Third Quarter 2004 Progress Report
Midwest Roadside Safety Facility
Mid-States Regional Pooled Fund
November 23, 2004

Pooled Fund Consulting Summary

Midwest Roadside Safety Facility
August 2004-October 2004

Figure 1. Type II Guard Fence End Terminal Standard Drawing

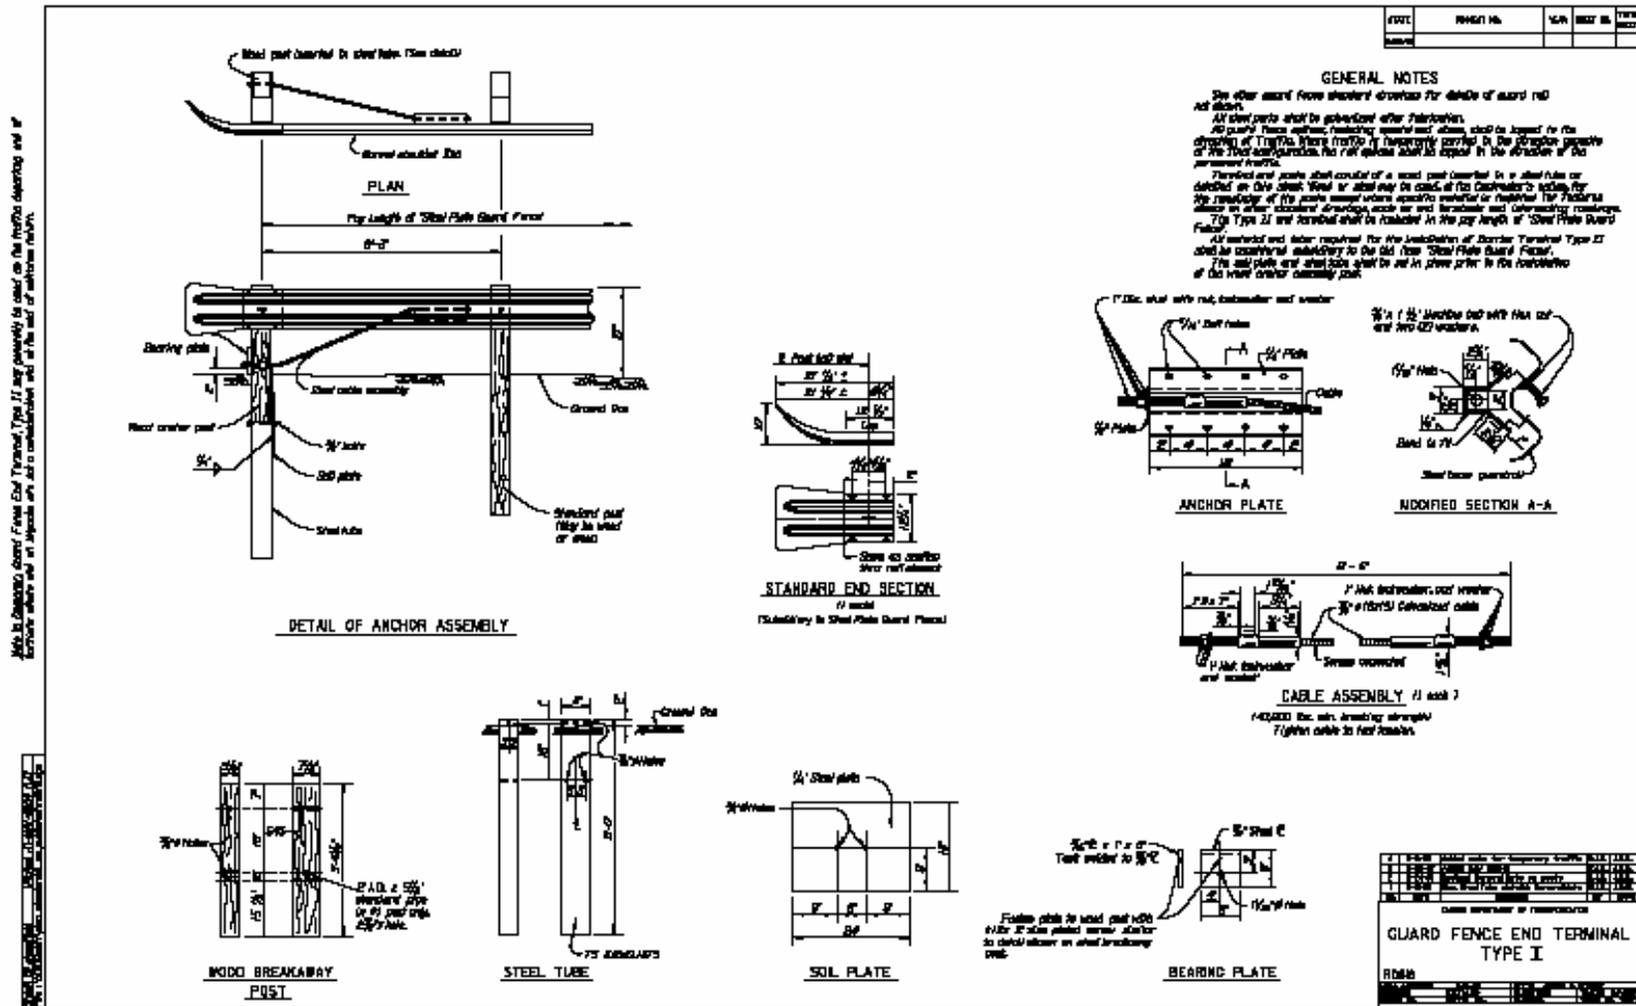
Ron, attached is a PDF for the Type II Guard Fence End Terminal Standard Drawing that we use on divided roadways when the end terminal is outside the clear zone.

Will our Type II end terminal anchorage system provide the required strength to develop the capacity of the rail? My concern is that this may be an item not studied to date based on 350 since the end terminals, temporary barrier, etc have been the main focus so far.

Bob and I briefly reviewed your detail and made a comparison to a new single, cable anchor post developed for Road Systems, Inc. and for use with the taller MGS in combination with FLEAT and SKT end treatments. In the comparison, the Ks DOT detail uses a shorter tubular post but a larger soil plate area. On the contrary, the Road Systems detail uses a longer wide flange anchor post instead of a tubular foundation member and in combination with a smaller soil plate area than currently used by Kansas.

In the absence of any testing and evaluation of your system, we may be more comfortable with Kansas increasing the length of the single anchor tube by 12 in. Please note that it may be possible that your existing system would meet the NCHRP 350 requirements for longitudinal, strong-post W-beam guardrail systems. However, we cannot make that final determination without full-scale vehicle crash testing. Therefore, in the interim and absence of testing, we recommend that you increase the tube length by 1 ft if you wish to continue the use of a single anchor tube in lieu of the two tube system adjoined with a channel strut.

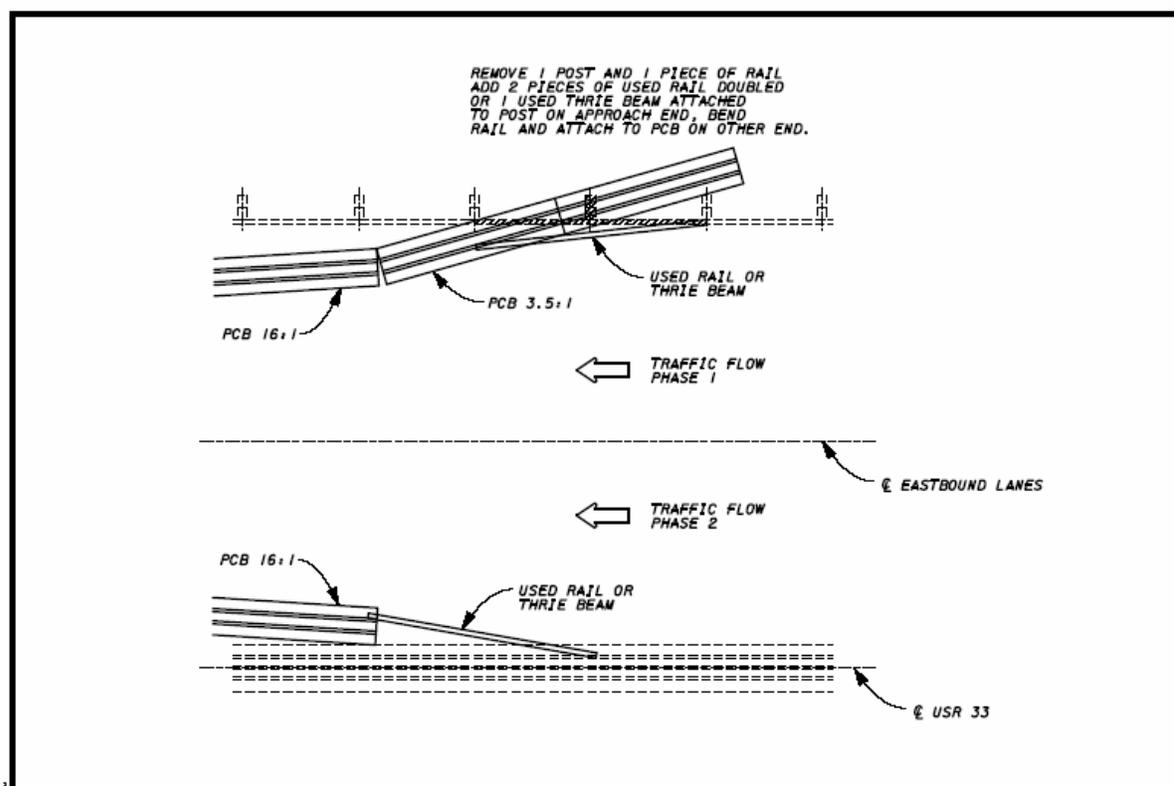
This designer is proposing using the attached design in two MOT phases. Phase 1 involves a PCB flared through a removed section of guardrail with a w-beam attached. Phase 2 shows a PCB flush against a permanent concrete barrier. We need to have a connection that could meet 350.

My proposed solution to Phase 1 would be to anchor the PCB in the last two sections (12.5' x 2 = 25'), and to use a nested w-beam section connect the old and the new. I would not see much a snagging issue. But maybe a steel wedge should be used at mid-span of the rail element and fastened to the PCB. Your thoughts would be appreciated.

For Phase 2, I have seen other designers use an impact attenuator at the end of the PCB and flush with the existing barrier. That would work, I assume. But I wonder if you have other ideas?

I see several problems when looking at your Phase 1 option. Transitioning from the PCB to the guardrail would prove difficult on many levels. First, there is not enough of a transition in the relative stiffness between the two systems. Your anchored PCB's would essentially be rigid, while your guardrail would be much more flexible. Thus, even though the potential for snagging is not great, there is still a significant potential for vehicle instability. In order to make that concept function, significant work would need to be done to transition between the stiffness of the flexible rail and the stiff PCB's. Your nested W-beam section is a start, but I don't believe it is sufficient to insure vehicle stability. The second issue with the Phase 1 transition is the anchorage of the guardrail. I have not looked into it sufficiently yet, but I am not sure you can get the necessary anchorage out of the PCB's.

Your Phase 2 option is closer to what we would recommend, but it would need to be modified as well. In order to alleviate snag concerns and stability problems, the guardrail section would need to approach the temporary barriers at a 15:1 flare at most. That would likely mean using a longer transition section of guardrail than you have drawn. In addition, a rubrail of some form would need to be installed below the regular rail, and special spacer blocks would have to be installed on at least 3'-1 1/2" spacing.

Standard Detail Drawing 14B20-6a

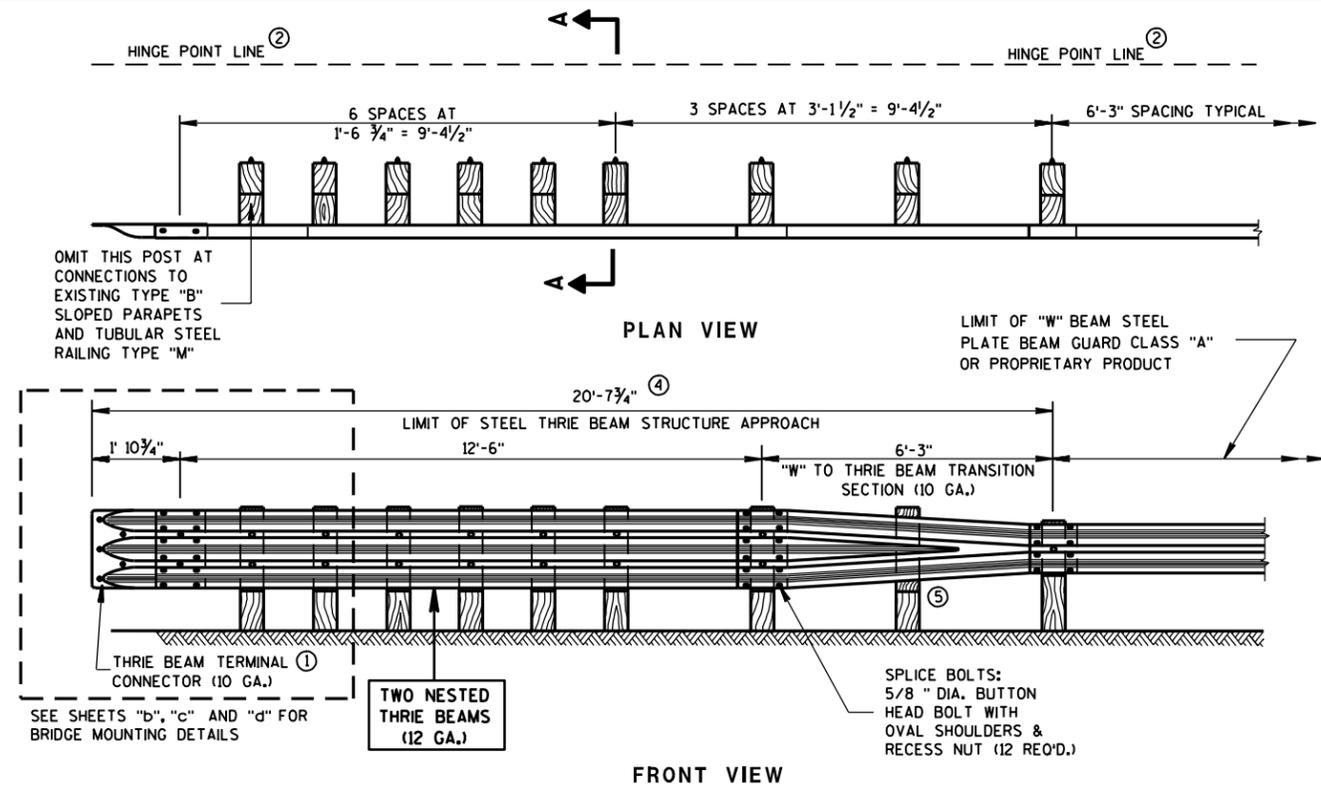
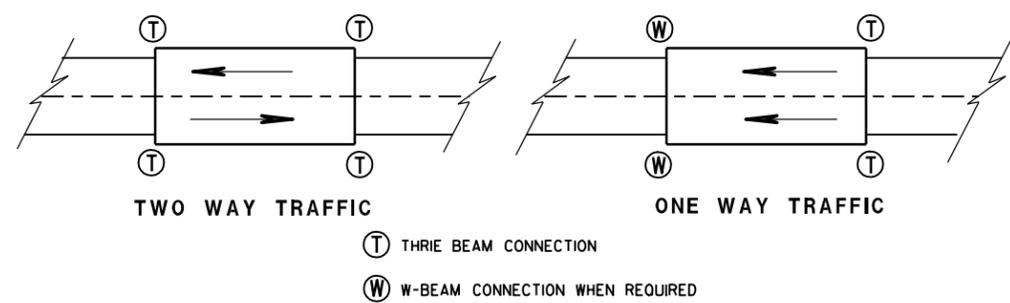
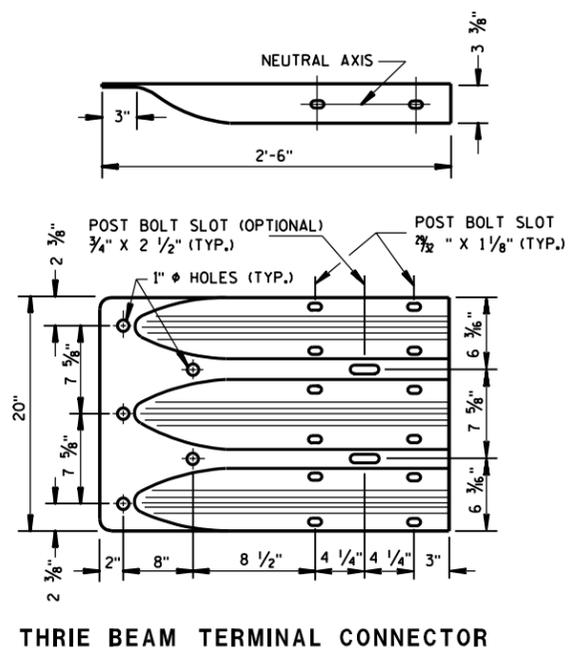
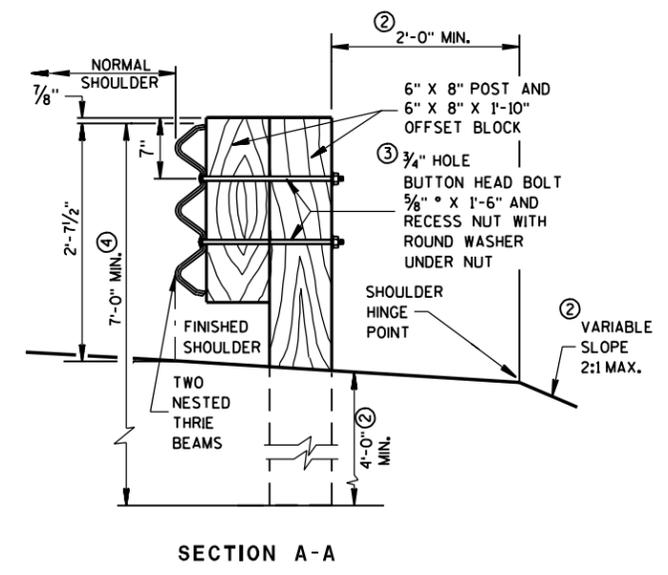
The attached Standard Detail Drawings (SDD), 08d2-4 & 08d3-4, show our current layout configurations for concrete surface drain flume and drop inlet at structure approaches. SDD 14b20-6a also (attached) is our typical three beam structural approach used at such locations. When SDD 14B20-6a is used with a flume or surface drain, post number 5 is usually eliminated as shown on SDD 08d2-4 and 08d3-4. Our concern is the elimination of this post compromises performance.

We are proposing using 8" x 8" x 7' posts for the two posts on either side of the flume or drop inlet. Another design change would be to move the flume or drop inlet further away from the structure or provide multiple flumes. We are aware of design flows with the surface drain details, especially on superelevated structures. Field review shows that they are not effective for high flows.

1. Removal of post no. 5 and using larger 8" x 8" posts for post nos. 4 and 6.

We would suggest that you not remove post no. 5 from the transition region. It is not certain how the existing transition will perform with that post removed, but there are concerns that removal of the post would create an area with significantly less stiffness than the tested design. Even if you increase the size of the adjacent posts to 8" x 8" the stiffness will not match the design with post no. 5 included.

As such, we would recommend that you use the second option, which is to move the flume. It appears from your drawing that the flume could be moved 37.5" so that it sits between post nos. 6 and 7. This would provide room for your flume while not adversely affecting the transition.
